SUBDIVISION REVIEW SHEET**CASE NO.:** C8J-2019-0090.2A**COMMISSION DATE:** October 17, 2023**SUBDIVISION NAME:** Stoney Ridge Highlands Phase 2 Final Plat**ADDRESS:** 7527 Elroy Road**APPLICANT:** KB Home Lone Star Inc.**AGENT:** Carlson, Brigrance & Doering, Inc. (Bill Couch, P.E)**ZONING:** SF-4A (single family residence)**NEIGHBORHOOD PLAN:** n/a / E.T.J.**AREA:** 15.503 acre (675,310.68 sf)**LOTS:** 98**COUNTY:** Travis**DISTRICT:** 2**WATERSHED:** Dry Creek East Creek**JURISDICTION:** Full Purpose**SIDEWALKS:** Sidewalks will be constructed along streets.**VARIANCE:** None**DEPARTMENT COMMENTS:**

CITY OF AUSTIN – TRAVIS COUNTY – SINGLE SUBDIVISION OFFICE
SUBDIVISION APPLICATION – MASTER COMMENT REPORT

CASE NUMBER: C8J-2019-0090.2A
UPDATE: U0
CASE MANAGER: Cesar Zavala Email: cesar.zavala@austintexas.gov

PROJECT NAME: Stoney Ridge Phase 2 Final Plat
LOCATION: 7527 Elroy Rd.

SHEET NO. 2 OF 5

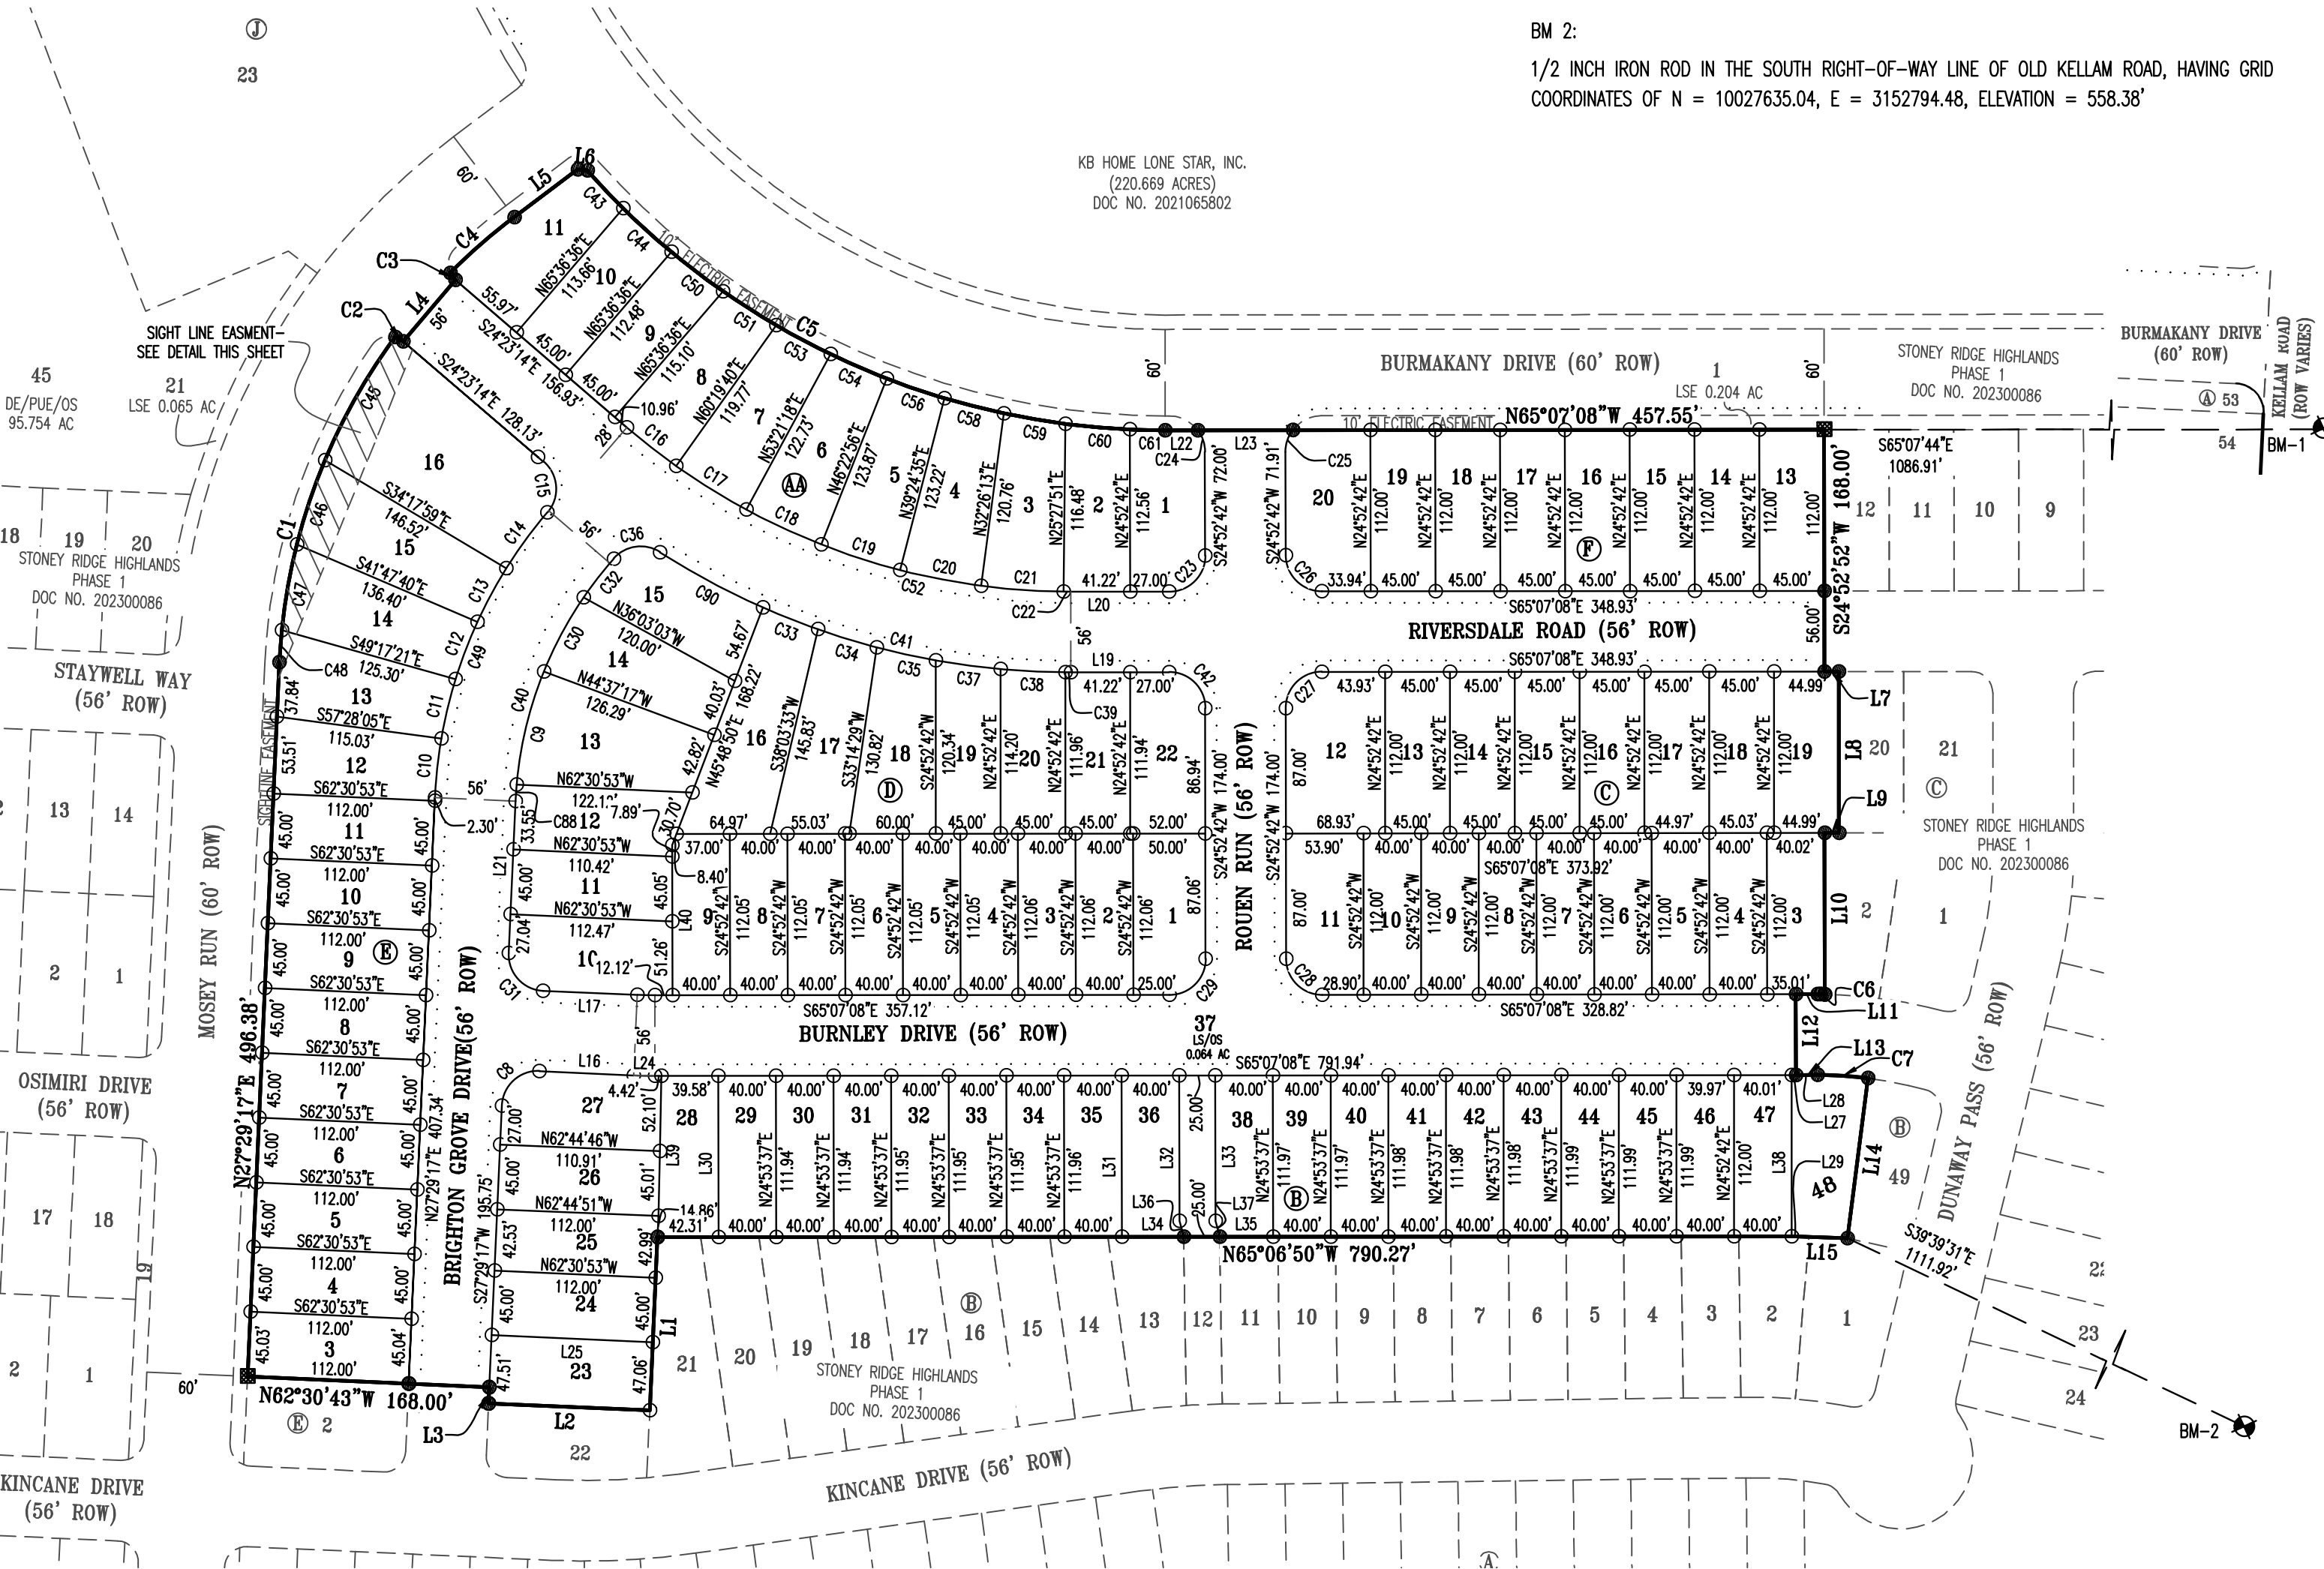
- SR 1. This application was initially submitted on September 18, 2023, and is subject to the following deadlines (25-1-83; 30-1-113; 25-4-84; 30-2-84; 25-4-85):
- Update deadline: December 18, 2023
 - Fiscal due (if any): March 18, 2024
 - All submitted for recording due: April 10, 2024
- SR 2. On Sheet #2, verify that all lots show metes and bounds or lot line measurements, Block F is missing lot line measurements along Burkmakany Drive. 30-1-113
- SR 3. Verify that the acreage totals for the lots and right-of-way are correct or are similar to the total acreage shown on the top left corner of Sheet #2. 25-1-83, 30-1-113:

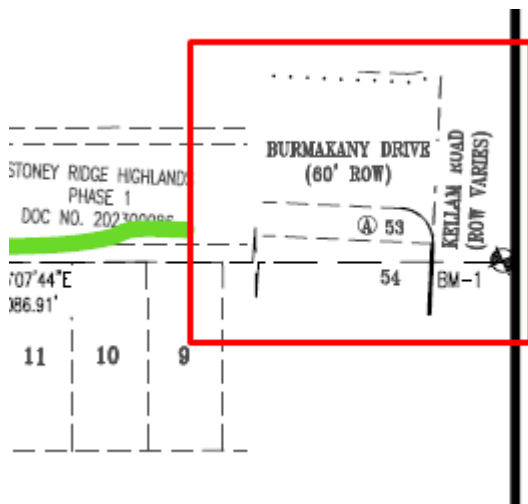
AD2: Please remove the bounded section in the image below since it does not accurately reflect the area by scale on sheet 2

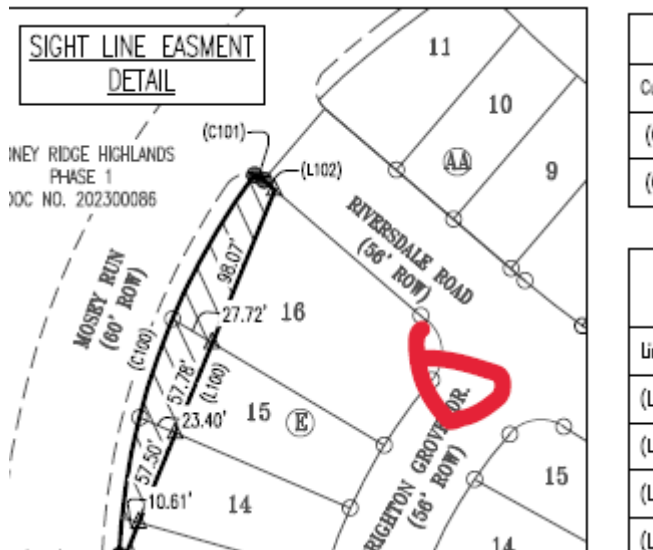
AD3: Please remove all forms of punctuation after abbreviating street types or directionals
